Product Change Notice (PCN)

Subject: Addition of support tapes on Lead Frame for ASE-KH products (LQFP-100pin) in RH850 Series.

Current mass-production products

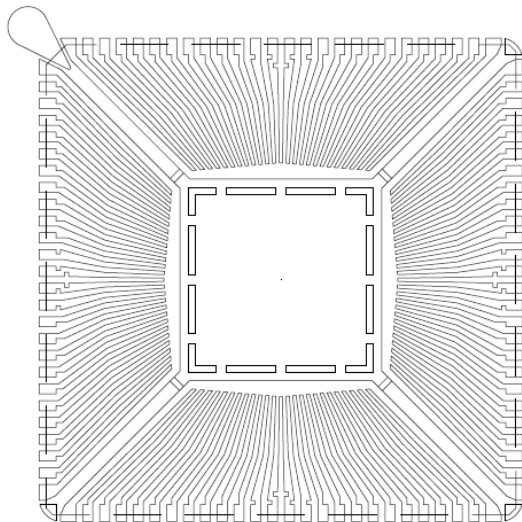
The change content is addition of support tapes on the inner-lead of Lead Frame.

The following is the image of Lead Frame for current mass-production products and changed products:

Changed products

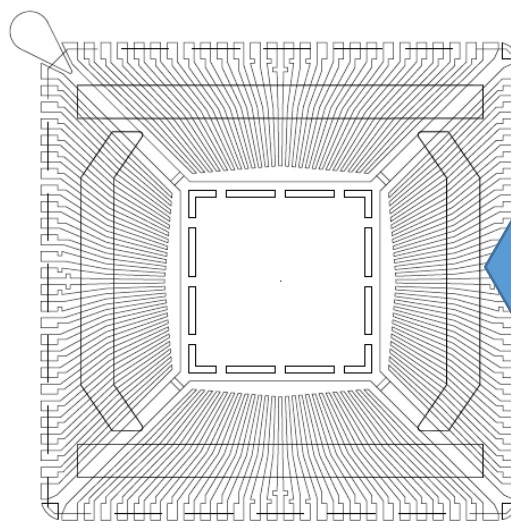
Support Tape

Manufacturers of Lead Frame will attach support tapes.
